# Historical Architectural Review Board

## COA Preliminary Review Sheet

**HDC-2025-00086**

**Proposal: Roof Replacement (Violation Correction)**

Current Material on Roof (Applicant)

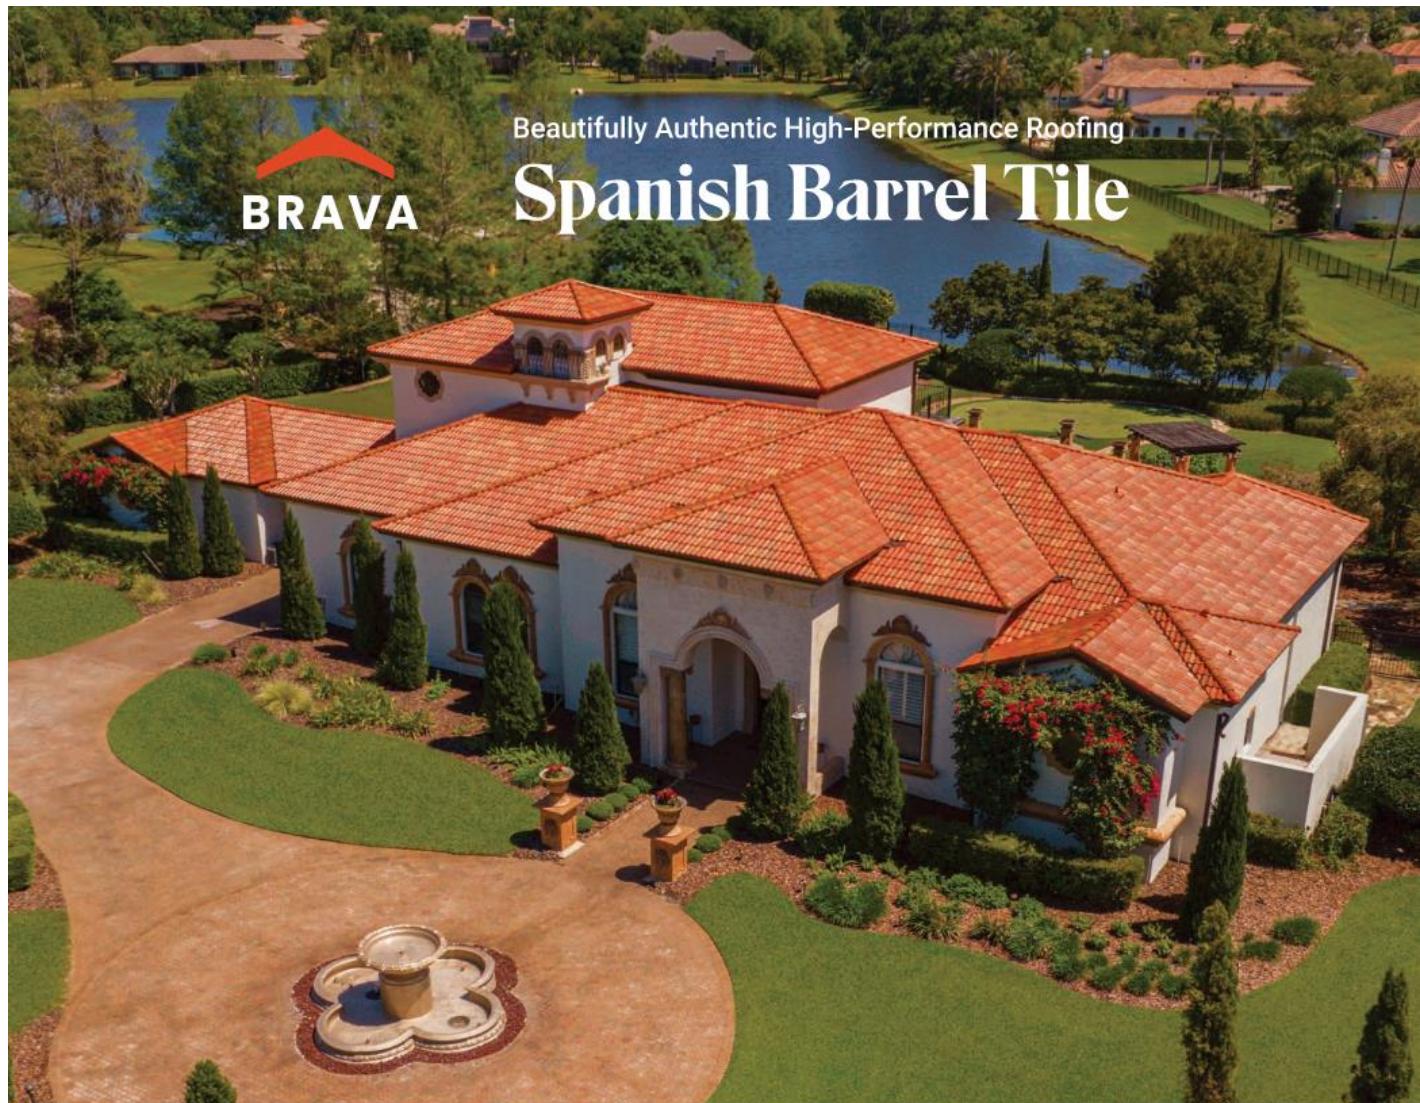
**Observations & Comments:** The original roof of 126-128 N 15 Street was Spanish barrel terra cotta clay tile. It appears that the original roofing materials have been completely removed at the main roof areas, and replacement with a red shake style architectural asphalt shingle was begun until work was stopped. The applicant has submitted an alternate material for review: Brava's Spanish Barrel Tile, a synthetic material that matches the original clay tile. This product appears to be an appropriate alternate material, as color options, profile, and appearance are consistent with the original historic clay. No specific color was proposed by the applicant. From the color chart, Antique Clay appears to be the closest match to the original clay; the applicant may obtain samples and submit photos to Staff showing the sample and the remaining original tile for final color selection.

The application does not indicate if the original clay tile at the projecting eaves at the first floor and the gable ends are intended to remain or be replaced with the other roof areas. If these areas are in sound condition, they should be

- The original clay tile at the projecting eaves at the first floor and gable ends are maintained and not replaced
- Proposed changes to any other roof-related elements such as gutters or downspouts are submitted in a separate application.
- Final color is approved by Staff

**Color Options (Applicant)**

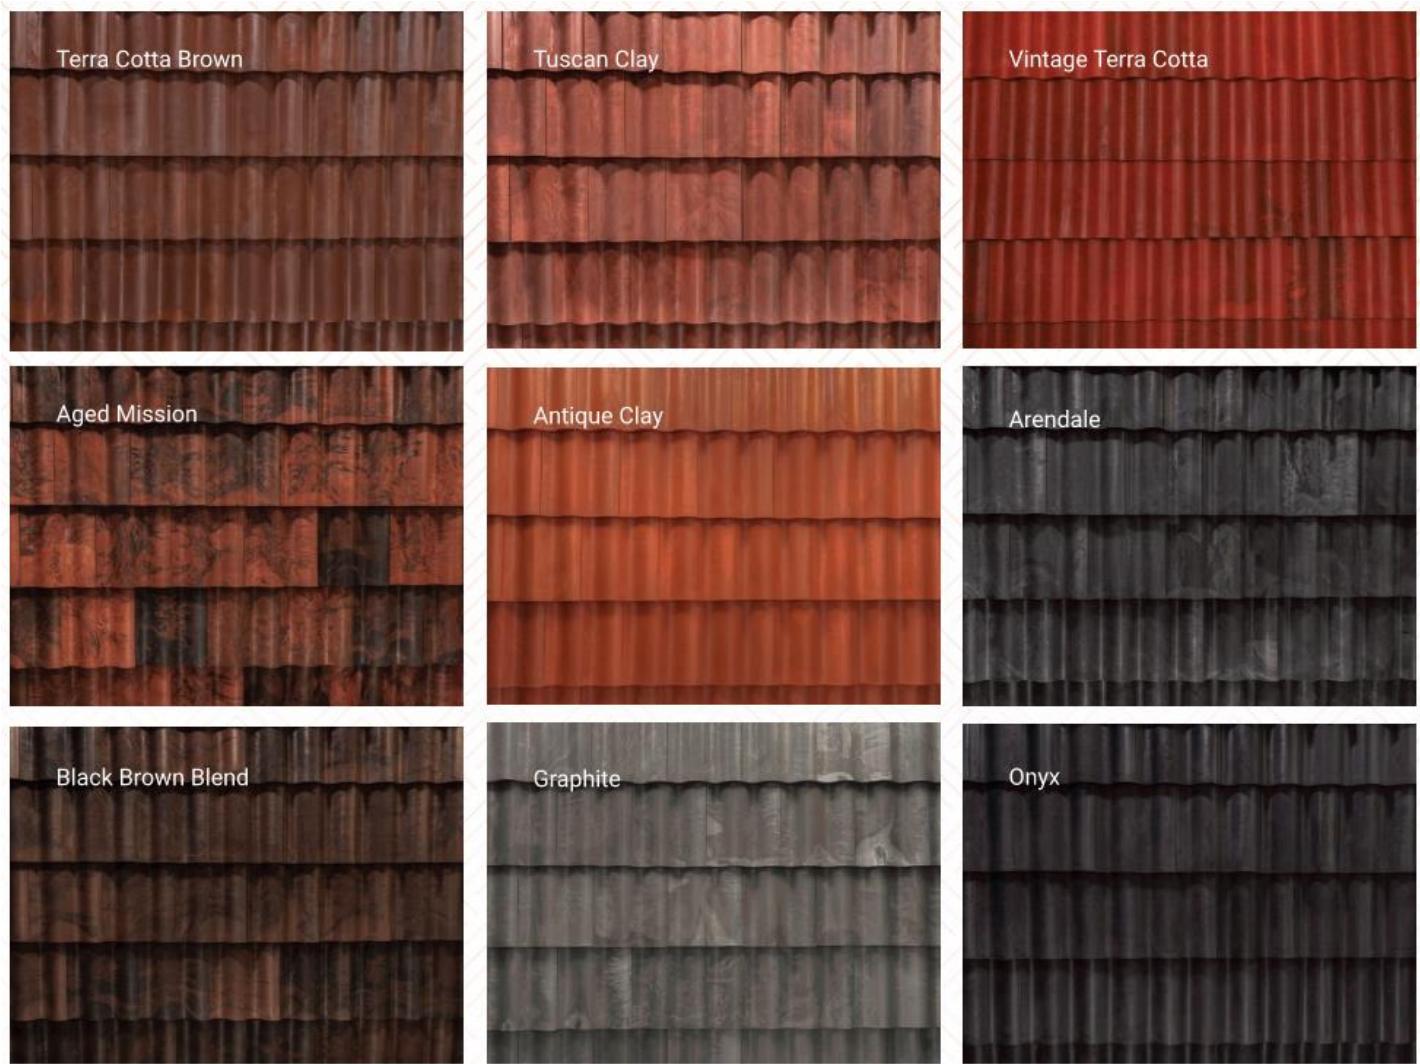
The applicant provided physical samples of Brava product; she noted that the samples show the Slate line, and not the Spanish barrel tile that is proposed for the project. The HARB reviewed the samples and product information and generally agreed that the Brava synthetic Spanish barrel tile appears to be an appropriate alternate material. The applicant noted that the bands of clay tile above the first floor level and at the gable ends are to remain, as are the existing gutters and downspouts.

The Board discussed roof detail areas, including hips, rakes, and ridges. Mr. Knee noted that these elements should be consistent across the roof. Mr. Hart noted that those elements are included in the manufacturer's product information. The applicant stated that all elements for the roof will be from the same manufacturer. Mr. Huber noted that the original valleys appeared to be open and copper. The applicant was unsure how the roofer would be detailing the valleys. The Board discussed that multiple approaches can be included in conditions. Mr. Knee noted that the valleys could be open or closed. Mr. Huber expressed that if the valleys were open, they should be copper to stay in keeping with the original material.

- Samples of the barrel configuration with colors closest to the existing color is submitted to staff for color approval. Photos submitted should show the samples next to the existing/original clay roof tile.
- The hips, rakes, and ridges are consistent in design throughout the roof and submitted to staff for approval.
- Detail for valleys to be submitted to staff for approval; if valleys are open they are to be copper, or the valleys can be closed as suggested in the manufacturer's documentation.
- The existing gutters and downspouts are maintained.
- If there are any other changes to roof components, a separate application will be made.
